# Access Compliance Report

## Public Rights-of-Way

### (Curb Ramps)

Intersection ID: 24399	Main Street: SUMMERLIN_PL	Cross Street: WINDYRUSH_RD	Location: SW
ADA ID: 899D49D07C75	Ramp Type: PerpDiag	Initial Pass/Fail: Fail	Overall Compliance: No
Severity Score: 25			
Codes/Mitigation Info/Possible Solution		Field Measurements/Component Compliance

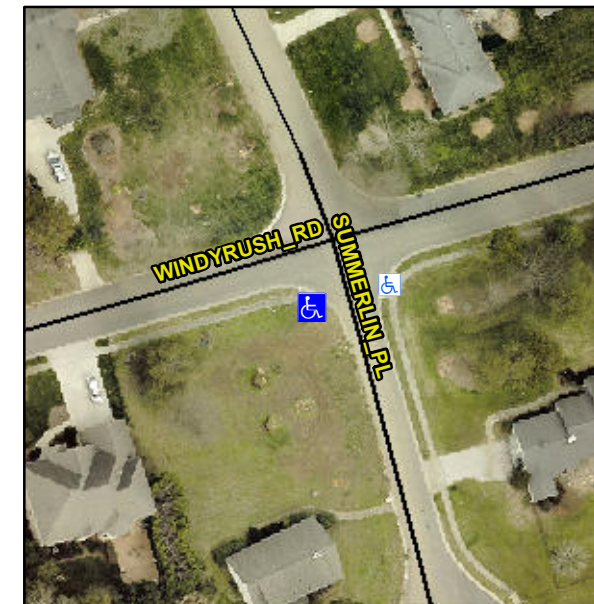
**Not Found, R304.5.3**

Compliance	Description	Data	Compliance	Description	Data
N/A	Ramp Length (in)	50.0	Yes	Ramp Slope (%)	8.1
Yes	Ramp Width (in)	48.0	No	Ramp XSlope (%)	8.9
N/A	Flare Type LT	N/A	N/A	Flare Type RT	N/A
N/A	Flare Slope LT (%)	N/A	N/A	Flare Slope RT (%)	N/A
N/A	Flare Traversable LT?	N/A	N/A	Flare Traversable RT?	N/A
N/A	Landing Length (in)	N/A	N/A	DWS Provided?	N/A
N/A	Landing Width (in)	N/A	N/A	DWS Contrast?	N/A
N/A	Landing Slope (%)	N/A	N/A	DWS Length (in)	N/A
N/A	Landing X Slope (%)	N/A	N/A	DWS Full Width?	N/A
N/A	Landing Curb? (Y/N)	N/A	N/A	DWS Offset (in)	N/A
N/A	Shared Landing?	N/A			
N/A	Gutter Ponding?	N/A	N/A	Gutter Slope (%)	N/A
N/A	Gutter Lip Ht (in)	N/A	N/A	Gutter X Slope (%)	N/A
N/A	Painted X Walk1?	No	N/A	Painted X Walk2?	No
	X Walk 1 Direction	To E		X Walk 2 Direction	To N
N/A	X Walk 1 Width (in)	N/A	N/A	X Walk 2 Width (in)	N/A
	X Walk 1 Slope (%)	3.5		X Walk 2 Slope (%)	3.7
	X Walk 1 X Slope (%)	6.0		X Walk 2 X Slope (%)	2.7

**Remove & Replace Curb Ramp With Two New Directional Ramps or Equivalent.**
